## ZHL-42W+ PCN Report

AN-60-072

As a result of the introduction of non heatsink version and assembly option at an alternate qualified Mini-Circuits facility, the replacement part has been judged by the Mini-Circuits Engineering team as a suitable replacement for the existing ZHL-42W+.

### CASE STYLE

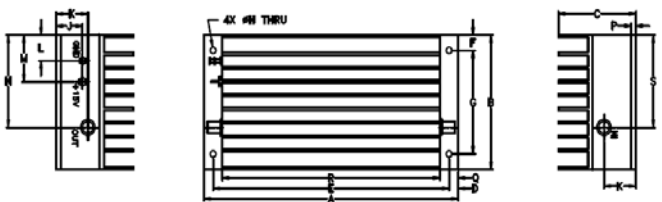
- 1) FIT and FORM are compatible with minor change: Create non heatsink version
- 2) Functional changes as follows:

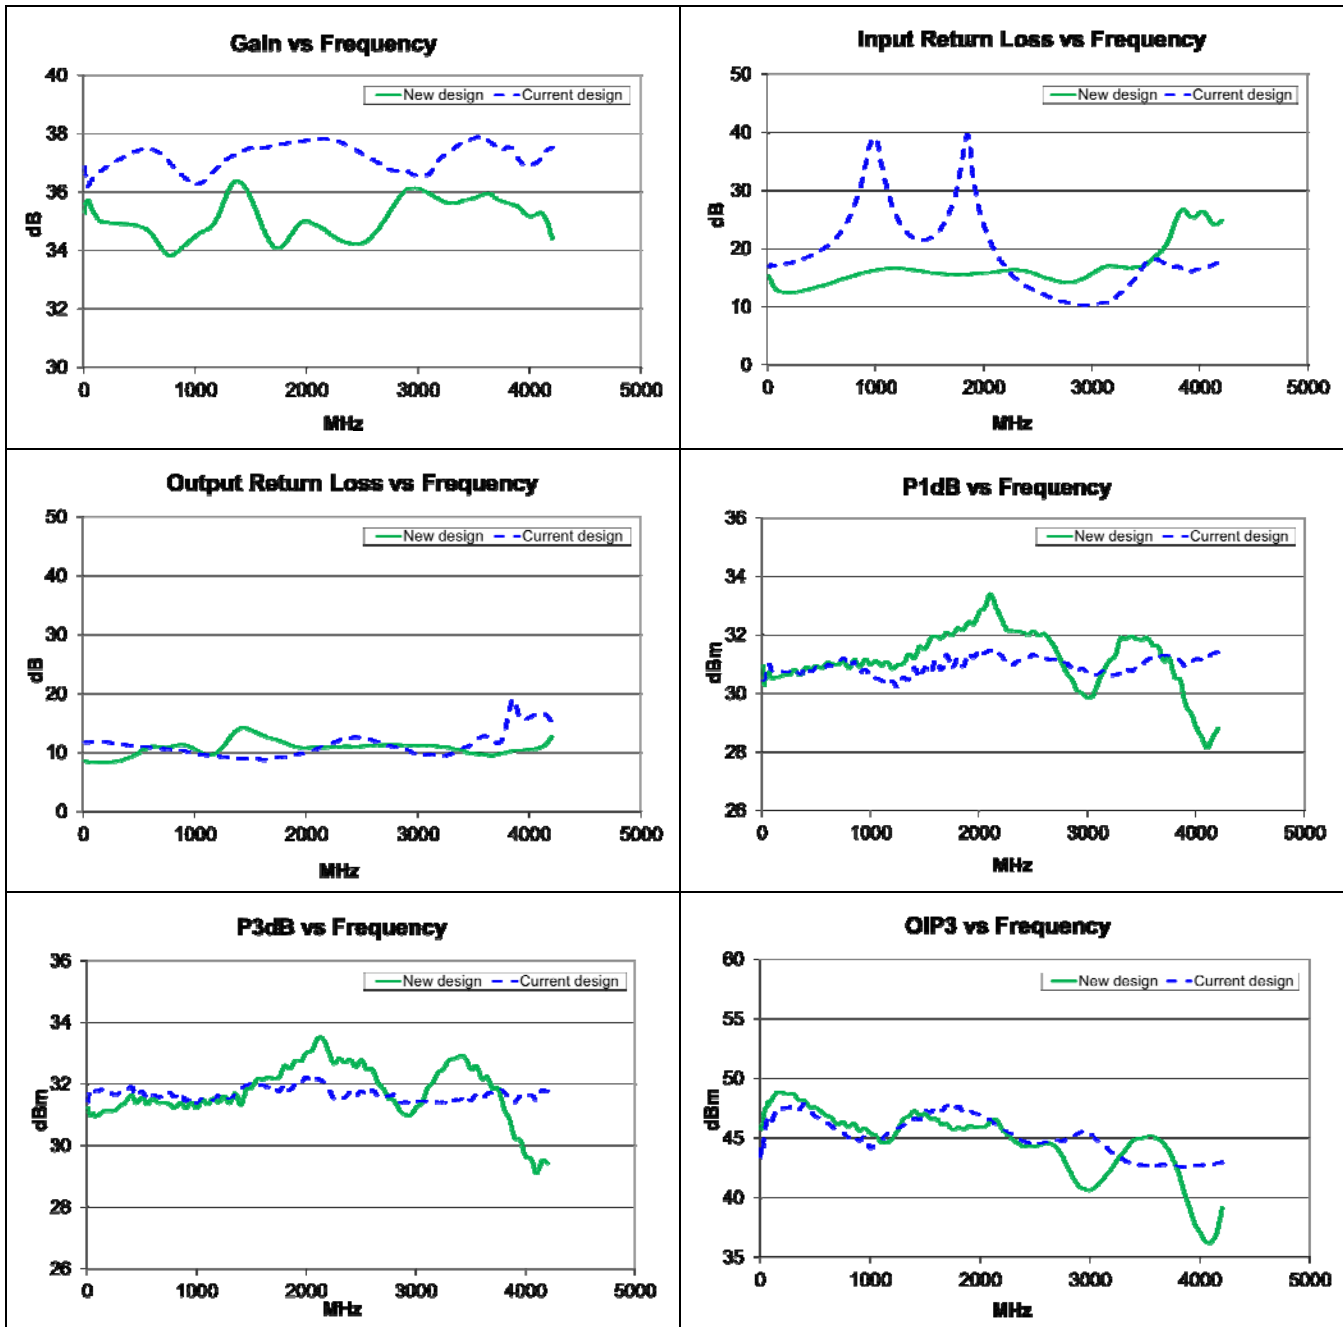
Parameter	Original Part, ZHL-42W+	Replacement Part, ZHL-42W+
Gain Flatness	+/-1.5dB max	+/-1.8dB max, +/-1.3dB typ
Output VSWR	2.5:1 max	2.7:1 max
P1dB	28dBm min* *27dBm at 10-700MHz	28dBm min***, 30dBm typ ***27dBm at 3700-4200MHz
P3dB	N/A	29dBm min****, 31dBm typ ****28dBm at 3700-4200MHz
Noise Figure	8dB typ** **Below 100MHz NF increases to 15dB at 10MHz	6dB typ
Supply Current	0.88A max	1A max

## COMPARISON PERFORMANCE CURVES<sup>a</sup>: $T_{AMB}=25^{\circ}\text{C}$

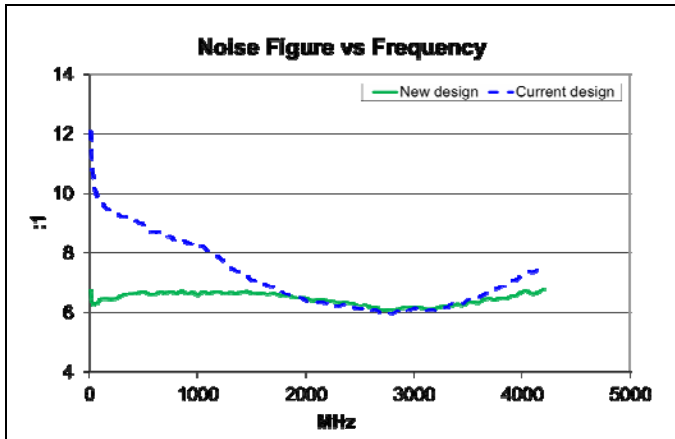
Parameter	Freq (MHz)	Current design (ZHL-42W+)		New design (ZHL-42W+)	
		Min	Max	Min	Max
Gain (dB)	10-4200	36.22	37.85	33.85	37.98
Gain Flatness (dB)	10-4200	-----	+/-0.81	-----	+/-1.31
Input VSWR (:1)	10-4200	-----	1.89	-----	1.64
Output VSWR (:1)	10-4200	-----	2.15	-----	2.42
P1dB (dBm)	10-3700	30.43	-----	30.29	-----
	3700-4200	30.64	-----	28.14	-----
P3dB (dBm)	10-3700	31.36	-----	30.96	-----
	3700-4200	31.42	-----	29.09	-----
OIP3 (dBm)	10-4200	42.62	-----	35.78	-----
Noise Figure (dB)	10-4200	-----	12.07	-----	6.79
DC Voltage (V)	-----	-----	15	-----	15
Supply Current (A)	-----	-----	0.64	-----	0.81
